ADDENDUM #1
TO
UPDATE #3
TO THE
TECHNICAL DRAINAGE STUDY
FOR
SUMMERLIN STORAGE
(MINI STORAGE FACILITY AT WESTCLIFF AND RAINBOW)
(APN 138-27-802-001)
IN
CITY OF LAS VEGAS, NEVADA

SUBJECT: **Addendum #1 to Update #3 to the Technical Drainage Study for Summerlin Storage (Mini Storage Facility at Westcliff and Rainbow), APN: 138-27-802-001 (DS5459H)**

Horrocks Engineers hereby submits Addendum #1 to Update #3 to the Technical Drainage Study for Summerlin Storage (Mini Storage Facility at Westcliff and Rainbow (DS 5459J) which responds to the CLV comments dated on December 27, 2023. The comments are listed below together with the associated responses.

FIGURE 7

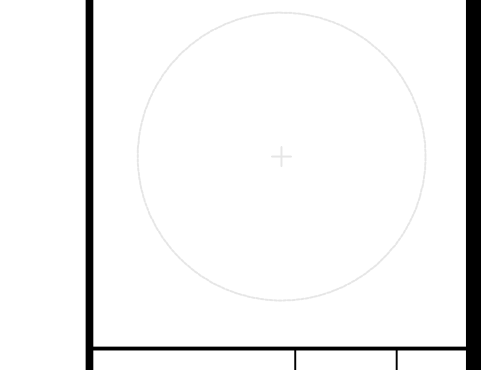
1. The slope of the swale along the west side of Building C and the north side of the property is less than 1%. Provide a 2'-wide concrete valley gutter for better drainage conveyance.

RESPONSE: A valley gutter has been included along the backside of Building C as requested. Updated normal depth calculations are provided in the Appendix. The swale along the north side now drains to the L-curb that conveys flow to the east. Cross Section 3 is still applicable and has not been revised. Figure 7 shows the updated Normal Depth Summary Table. An Updated Finished Floor Table can also be found in the Appendix with the updated flow depths. The proposed buildings still meet finished floor criteria.
